Proposed Revisions to a Standard Plans Index

Index Number: 700-031

Sheet Number (s): 2 of 2

Index Title: External Lighting for Signs

INDEX
700-031

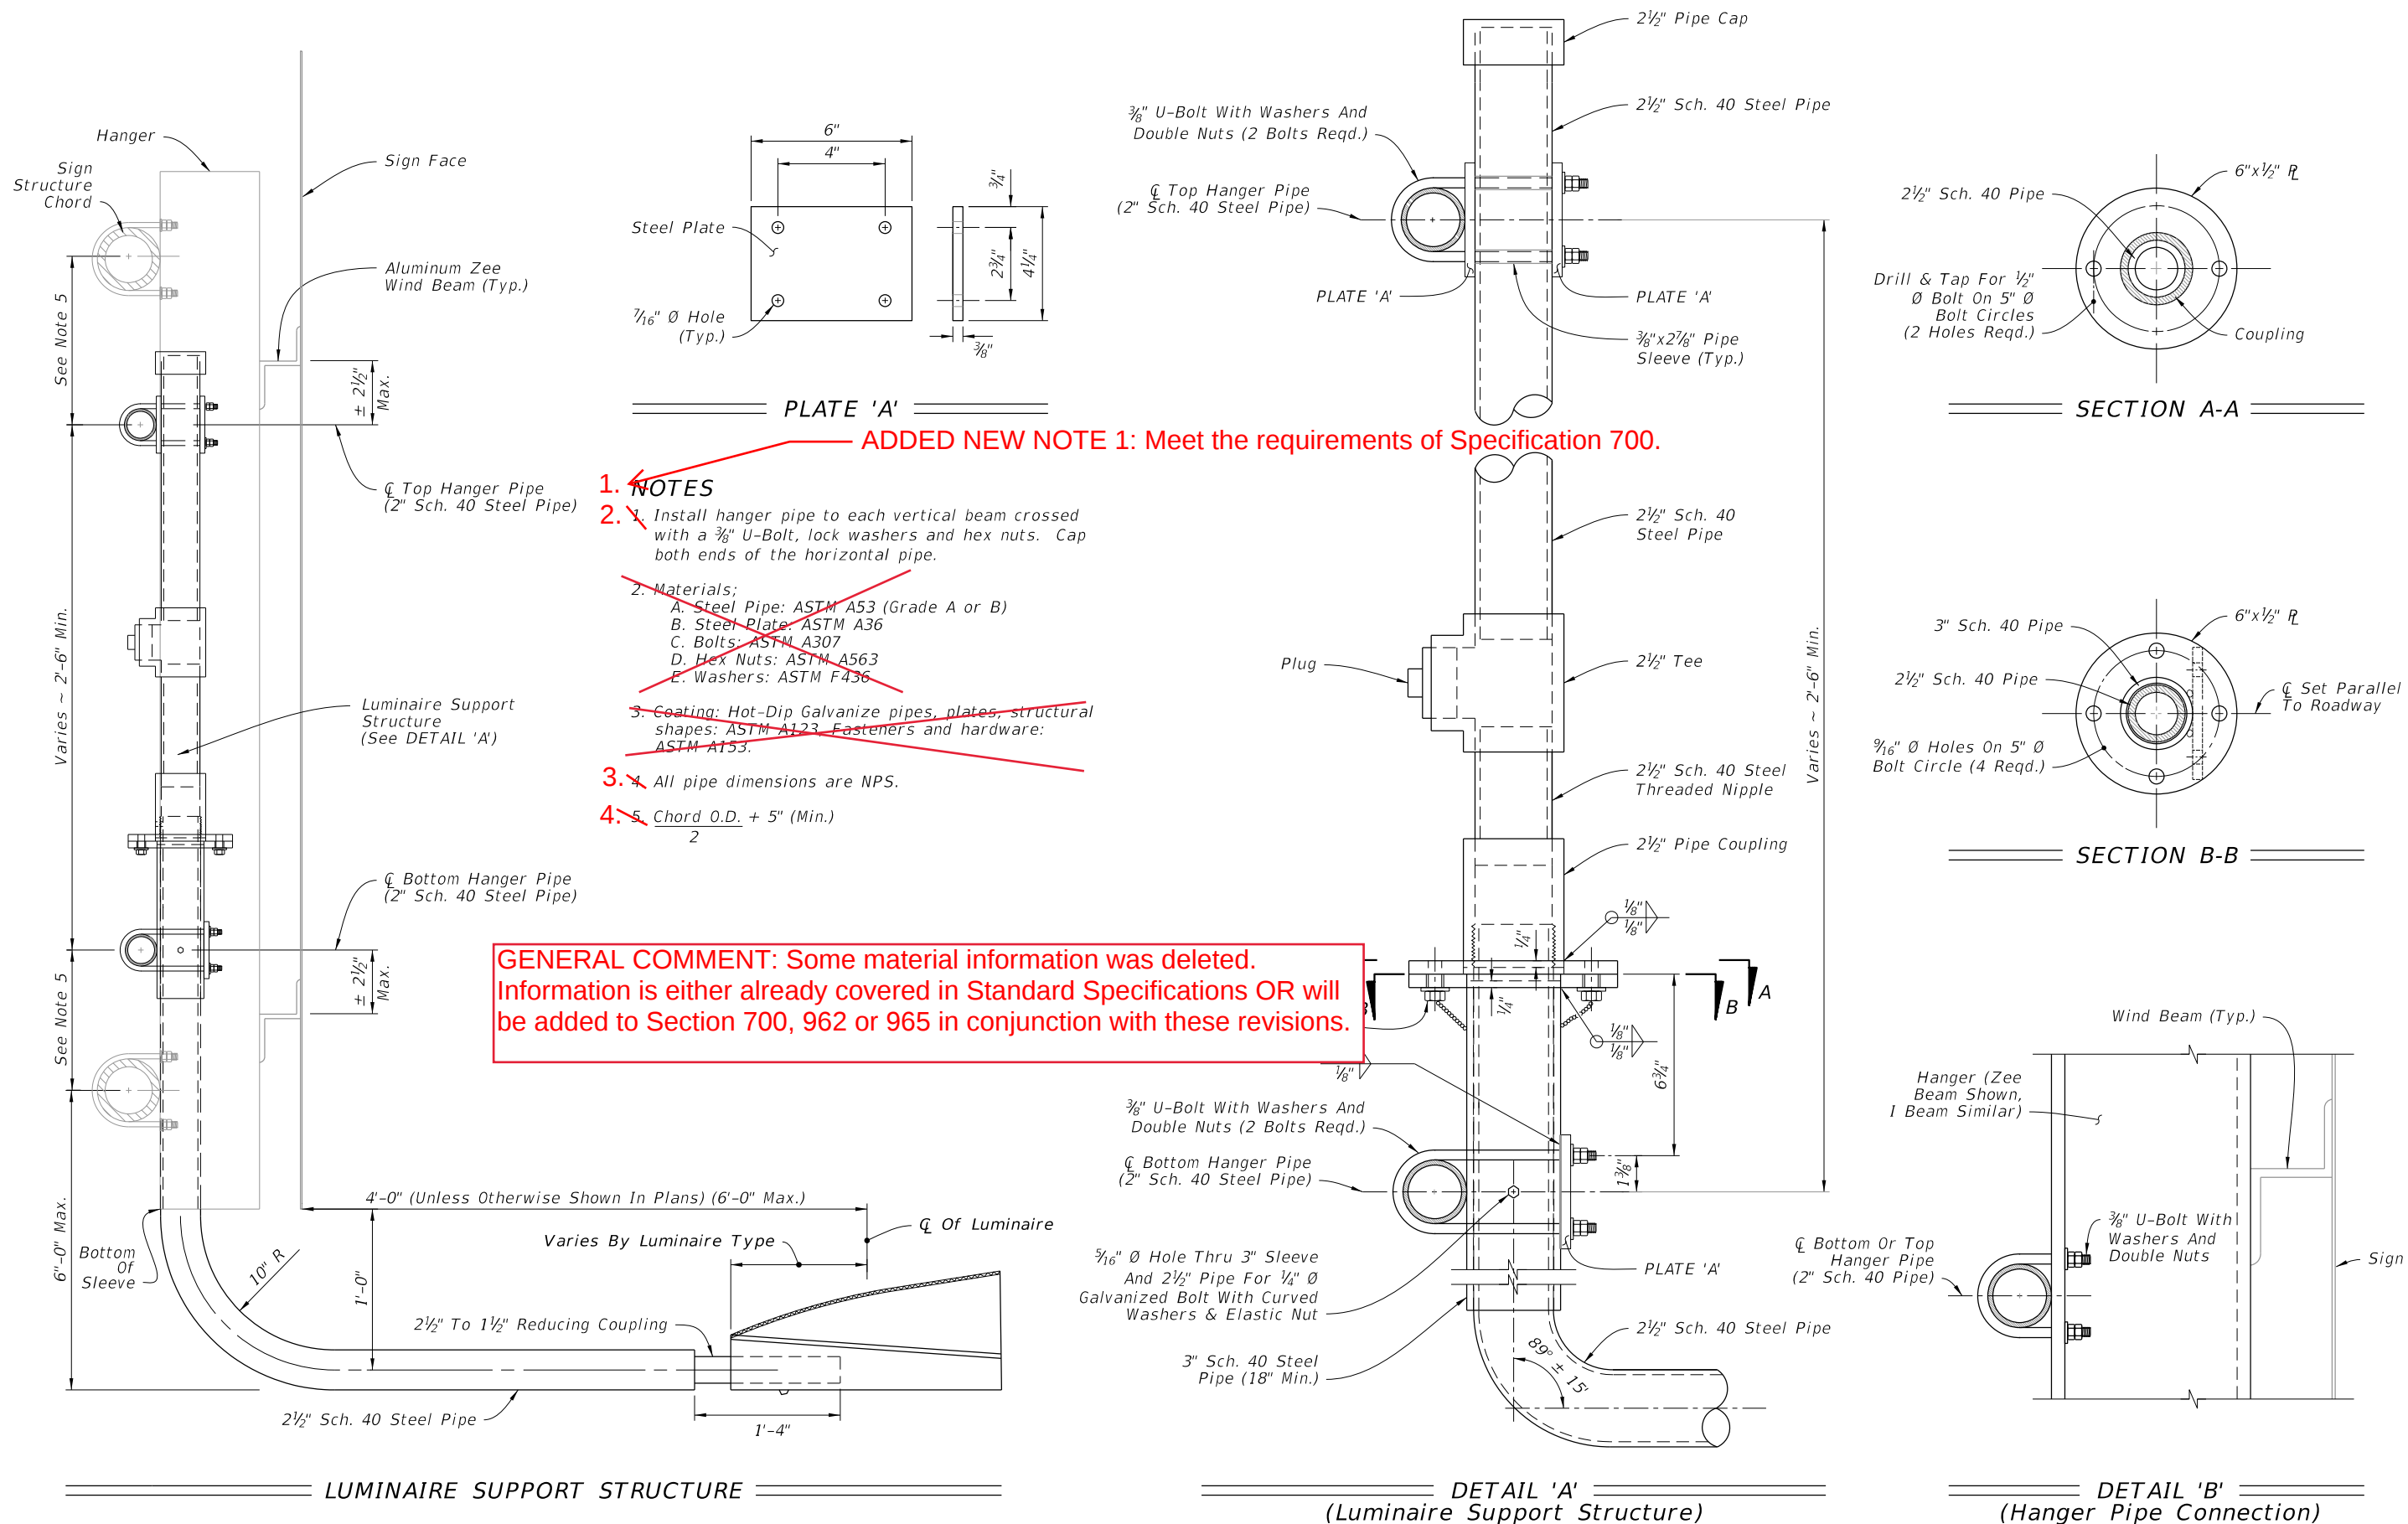
Added Note 1 - "Meet the requirements of Specification 700"; Deleted Note 2 and 3; Renumbered Notes.
